SUBJECT: Revs to application for amend to Licenses NPF-10 & NPF-15,
 revising Tech Specs re cycle dependent values & power
 distribution limits. Marked-up Tech Specs encl.

Subject: Docket Nos. 50-361 and 50-362
San Onofre Nuclear Generating Station
Units 2 and 3

REQUIRED REVISIONS TO PCD NPF-10/15-52

REQUIRED REVISION TO PCD NPF-10/15-85

FIGURE 3.2-1 CYCLE 2 DNBR MARGIN OPERATING LIMIT
BASED ON COLSS.

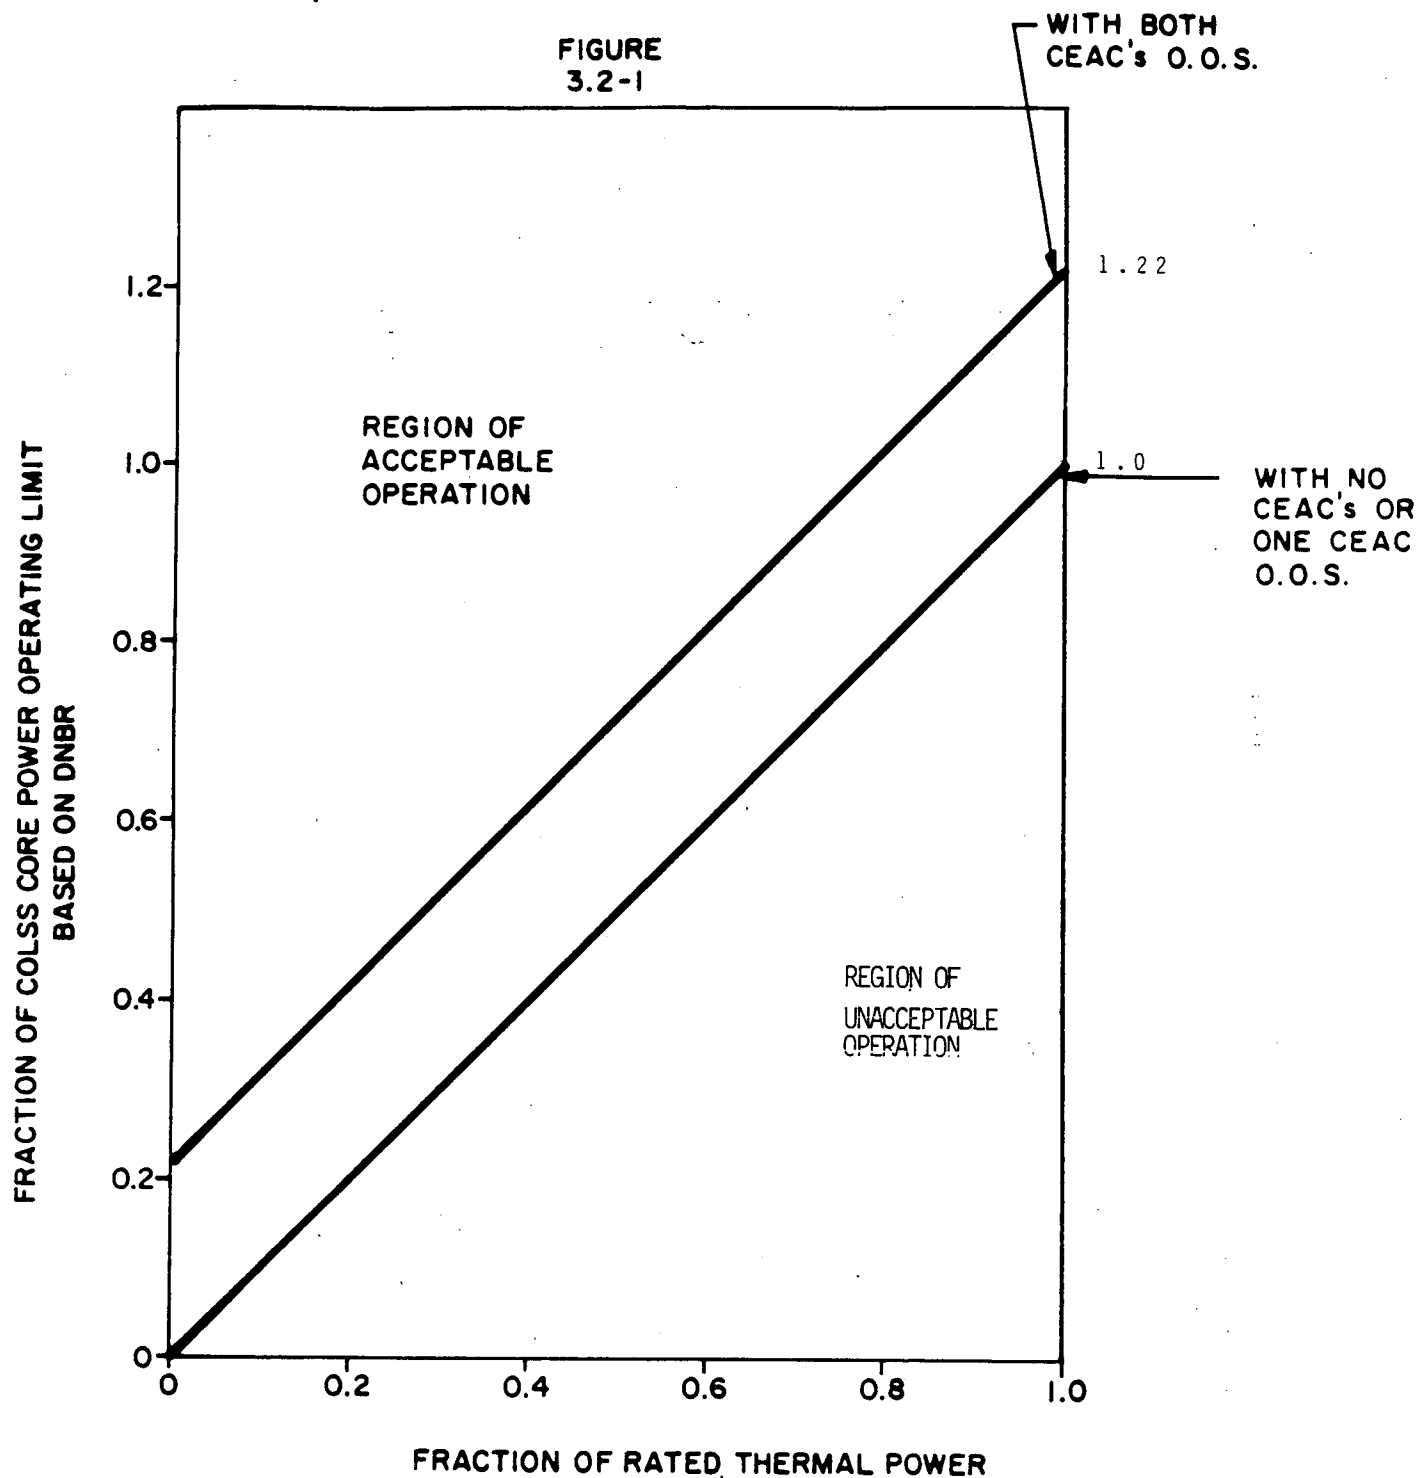
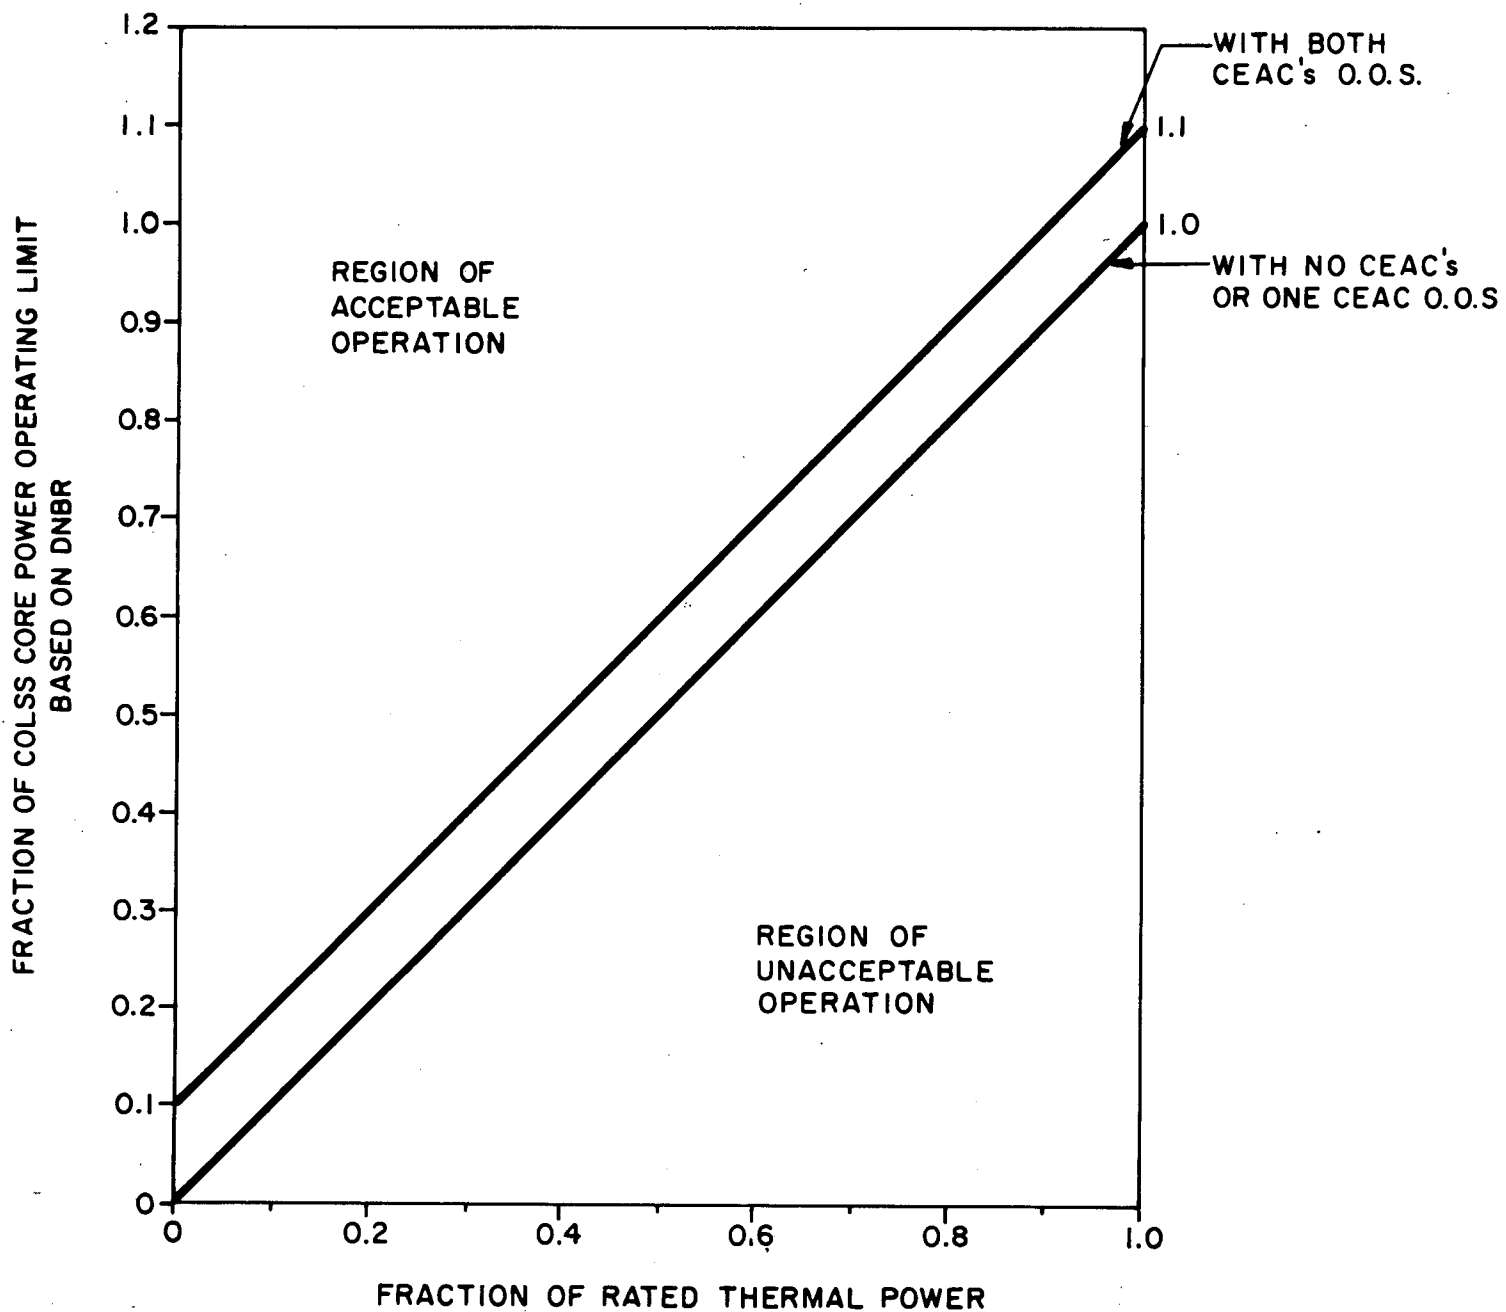
Proposed Change NPF-10/15-52 would revise technical specification Figures 3.2-1 and 3.2-2, and add a new figure 3.2-3 and Technical Specification 3/4.3.1, Action 6c. Figure 3.2-1, "DNBR Margin Operating Limit Based on COLSS," defines the region of acceptable plant operation when the Core Operating Limit Supervisory System (COLSS) is in service.

Proposed Change NPF-10/15-52 adds a second limit line to Figure 3.2-1 to address the case when COLSS is in service and both Control Element Assembly Calculators (CEAC's) are out of service. For Cycle 1, when both CEAC's are out of service, the second limit line requires that the COLSS calculated Power Operating Limit (POL) be 22% (of rated thermal power) higher than when one or both CEAC's are in service. For Cycle 2, the corresponding second limit line requires that the COLSS calculated POL be 10% higher versus the 22% for Cycle 1. The Cycle 2 reduction from 22% to 10% results from the xenon redistribution penalty for CEA withdrawals being less for Cycle 2 than for Cycle 1.

Figure 3.2-1 shows the minimum required COLSS calculated POL based on DNBR for a given reactor power level. Provided that the COLSS POL is greater than that required by Figure 3.2-1 for a given reactor power, the plant is operating in the region of acceptable operation.

The proposed change adds a note to Figure 3.2-1 which indicates that the current defined region of acceptable operation is equally applicable with either one or both CEAC's operable. A second COLSS calculated POL limit line, which requires a higher POL (an additional 22% of full power) for a given reactor power, is added to define the region of acceptable operation when both CEAC's are inoperable. This Figure 3.2-1 is applicable only to Cycle 1 (prior to first refueling) operation. A second Figure 3.2-1, which is applicable to Cycle 2 (i.e., following first refueling), is also added. The Cycle 2 Figure 3.2-1 requires a smaller increase in COLSS calculated POL (10% versus 22%) when both CEAC's are out of service than was required in Cycle 1. This difference results from a lower xenon distribution penalty for CEA withdrawals in Cycle 2 than in Cycle 1.

FIGURE 3.2-2 DNBR MARGIN OPERATING LIMIT BASED ON CORE PROTECTION CALCULATORS (CYCLE 2, COLSS OUT OF SERVICE, WITH RATED THERMAL POWER $\geq 70\%$)

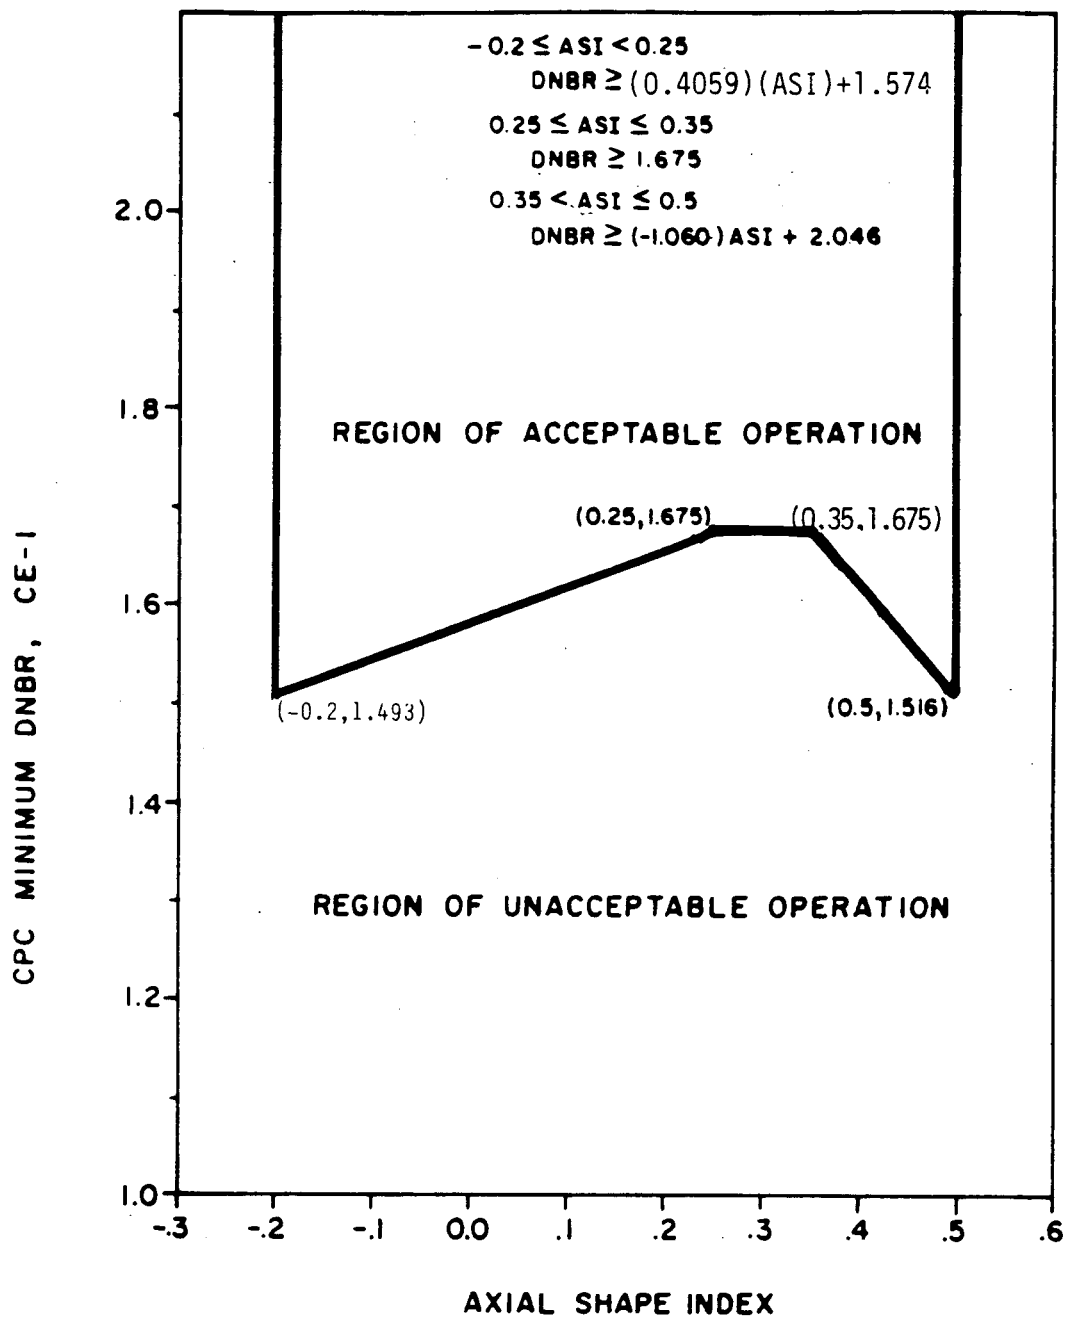
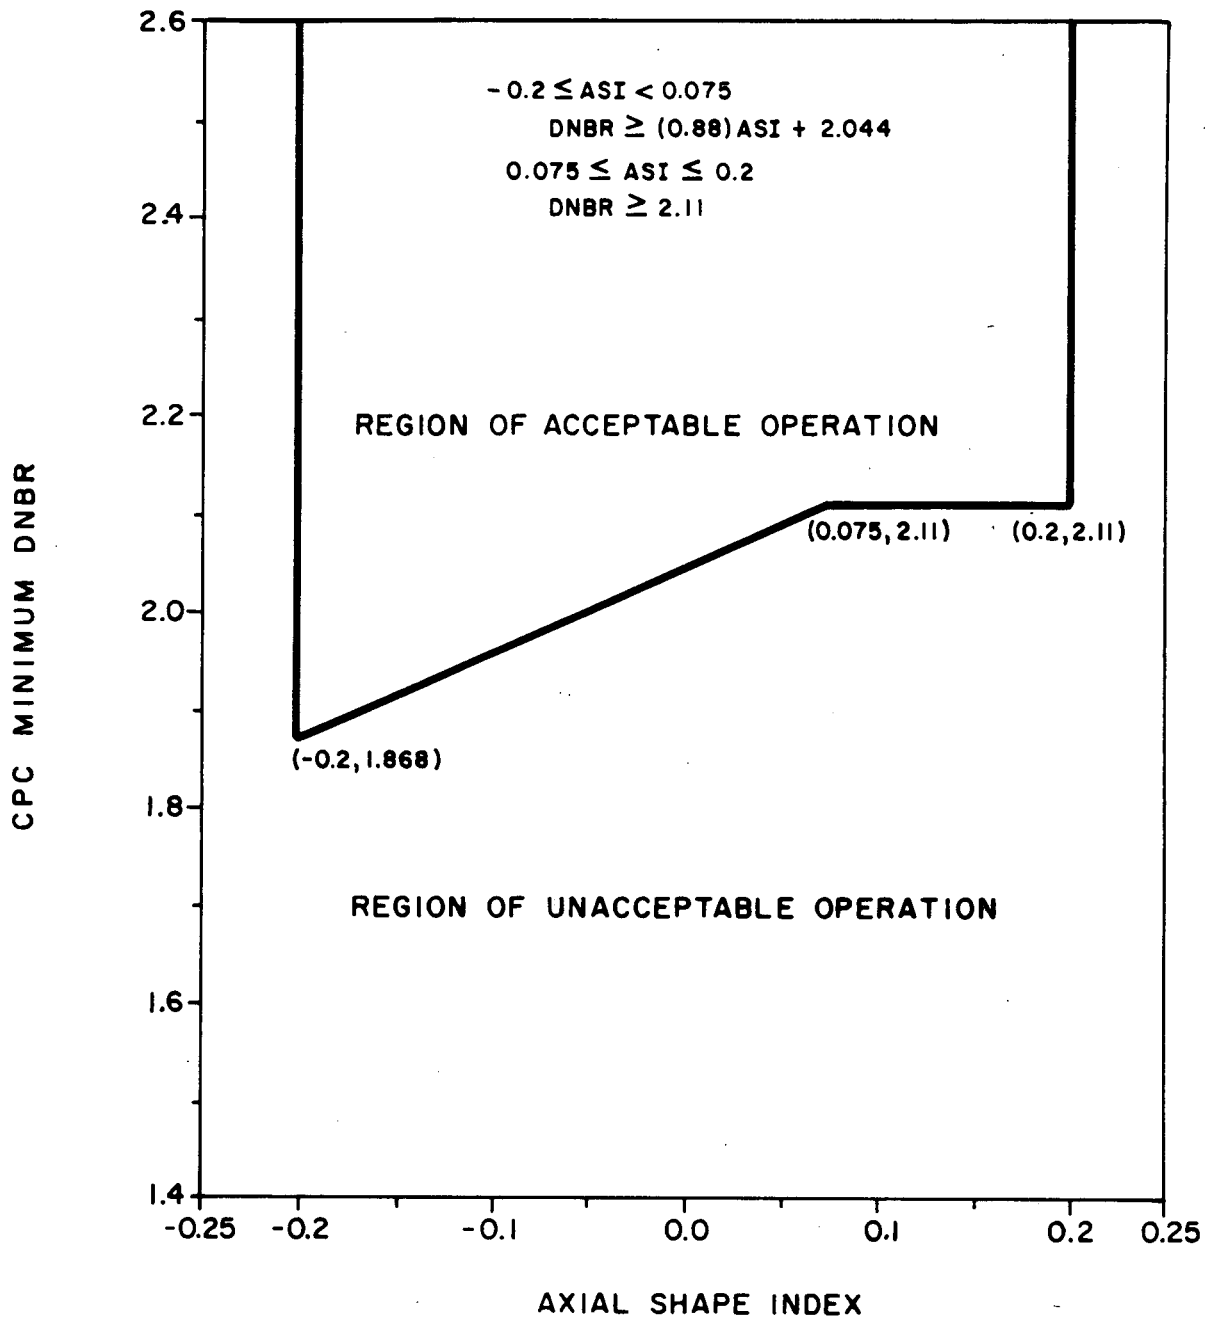
Figure 3.2-2, "DNBR Margin Operating Limit Based on Core Protection Calculators (COLSS out of service)," defines the region of acceptable plant operation when COLSS is out of service. Proposed Change NPF-10/15-52 splits Figure 3.2-2 into two new figures, 3.2-2 and 3.2-3. Figure 3.2-2 defines the region of acceptable operation for reactor power levels greater than or equal to 80% power. Figure 3.2-3 applies for reactor power levels less than 80%. The split was made to take advantage of lower measurement and calculational uncertainties at higher power levels thereby maximizing plant power capability when COLSS is out of service. In addition, both of the proposed Figures 3.2-2 and 3.2-3 incorporate a reevaluation of CPC uncertainties which resulted in a reduction of minimum required DNBR at all power levels. Both of the proposed Figures 3.2-2 and 3.2-3 are cycle specific and must be updated for Cycle 2. For Cycle 2, the breakpoint between the two figures is at 70% power rather than 80%, with Figure 3.2-2 applying for power levels greater than or equal to 70% and Figure 3.2-3 below 70%. Both figures have minimum DNBR requirements which are greater than their Cycle 1 counterparts. This increase in minimum DNBR requirements results from the CPC's providing a reactor trip on reactor coolant pump (RCP) speed for protection for the Loss of Flow (LOF) event in Cycle 2, rather than on the DNBR-flow projection used in Cycle 1. This change in the manner which CPC generates a loss of flow trip directly impacts the results of the Loss of Flow transient analysis, which is the limiting Anticipated Operational Occurrence (AOO) in determining margin requirements at full power. Because COLSS, when in service, reserves the required margin in terms of underflow fraction to account for margin degrading during the LOF transient, additional margin must be reserved in Figures 3.2-2 and 3.2-3, when COLSS is out of service.

When COLSS is out-of-service, DNBR margin is monitored using the CPC's. The COLSS out-of-service DNBR margin requirements are currently specified by Figure 3.2-2 which relates the required minimum DNBR based on the CPC's to Axial Shape Index, a measure of power distribution within the core.

The proposed change splits Figure 3.2-2 into two new figures, 3.2-2 and 3.2-3. Figure 3.2-2 defines the required minimum DNBR for reactor operation at greater than or equal to 80% power. Figure 3.2-3 defines the minimum required DNBR for reactor power levels of

less than 80%. The current Figure 3.2-2 is split into two new figures in order to take advantage of lower measurement and calculation uncertainties at higher powers which result in a reduction of the minimum DNBR requirements at higher powers. In addition, in both of the proposed Figures 3.2-2 and 3.2-3 a reevaluation of CPC uncertainty has reduced the minimum DNBR requirements by approximately 10% at all power levels. Thus, under the proposed change, when COLSS is out-of-service, the plant will be able to operate at a higher power level (i.e., with lower minimum DNBR). These Figures 3.2-2 and 3.2-3 are applicable only to Cycle 1 operation. A second Figure 3.2-2 and 3.2-3 are added which are applicable to Cycle 2 operation. In Cycle 2, Figure 3.2-2 is applicable at powers greater than or equal to 70% (versus 80% in Cycle 1) and Figure 3.2-3 is applicable below 70%. In Cycle 2, both figures require higher minimum DNBR than is currently required by either the existing T.S. or the proposed Figures 3.2-2 and 3.2-3 for Cycle 1. This results from changes in the manner in which CPC's will generate a reactor coolant low flow trip in Cycle 2. To accommodate this CPC change, more margin must be reserved in Figure 3.2-2 and 3.2-3 to provide the same level of protection against a loss of flow event, the limiting anticipated operational occurrence.
